In the Drawings:

REMARKS

Prior Art
FIG.17

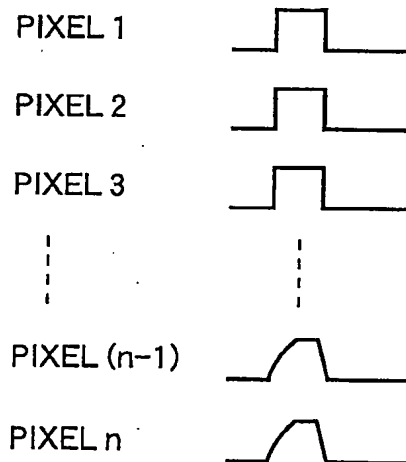
The attached sheets of drawings include changes to Figs. 16-19. Annotated sheets showing the changes are attached. The replacement sheets contain the words "Prior Art" and replace the originally filed sheets.
